Waste and Recycling

RE: 26/00318/FP

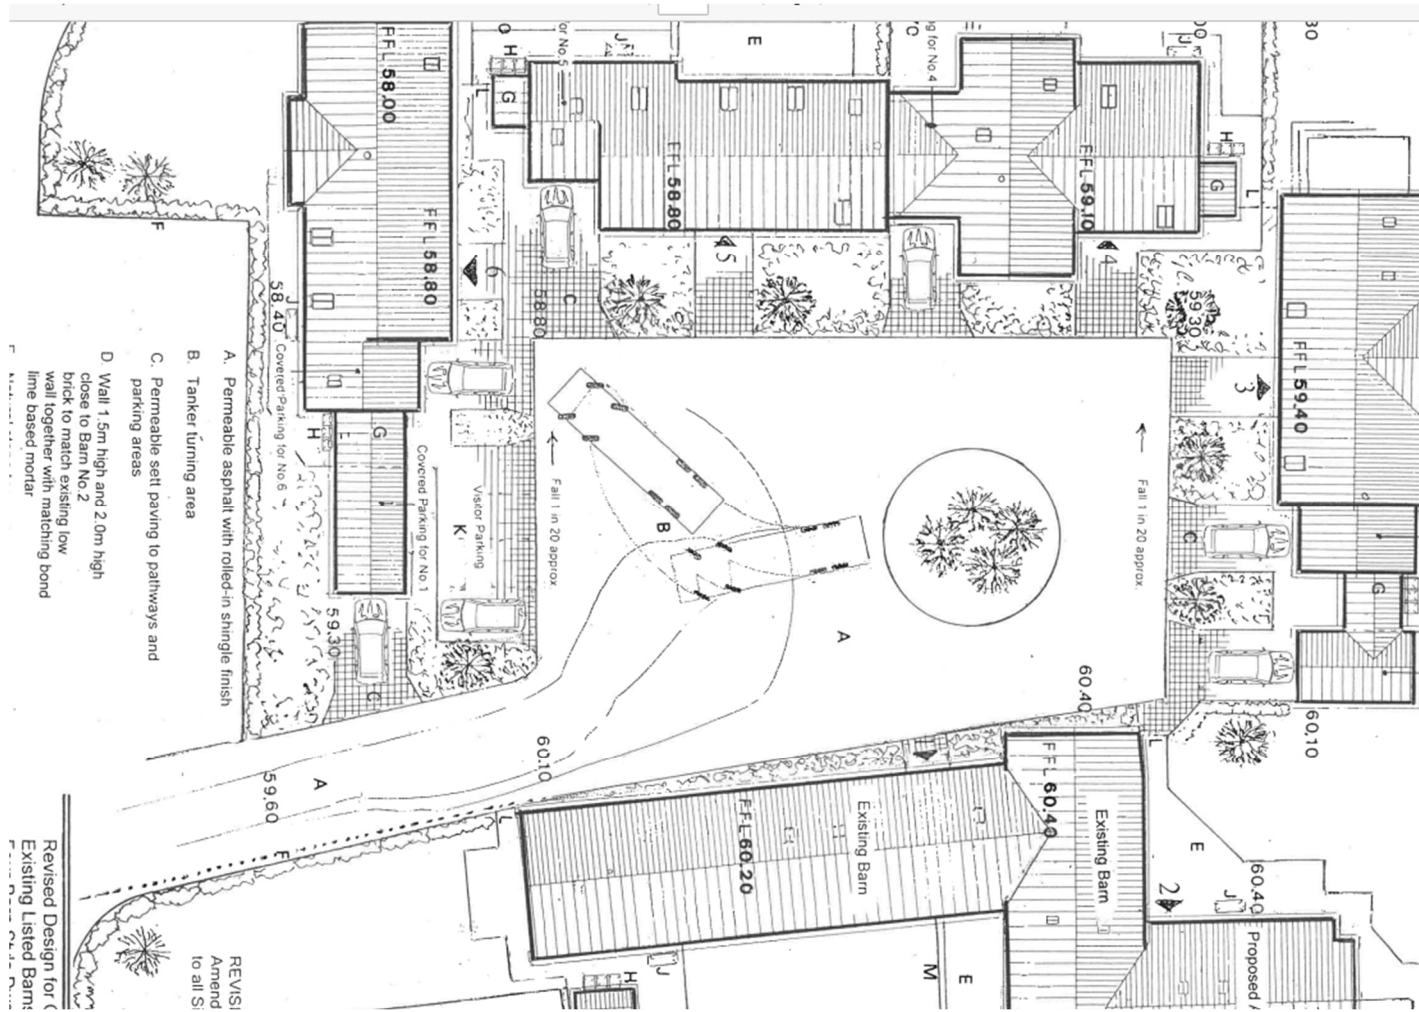
*We would always prefer for the RCV to enter and exit an estate/development forward first on all occasions.

*The plan

Does not account for any cars parked on the road, this would make this turning and reversing area even tighter.

*The properties most North/to the right of the above map, are further from the closest point our vehicle can access than the preferred pull and return distance. Assuming these properties are all going to be issued with their own household bin set up and not communal.
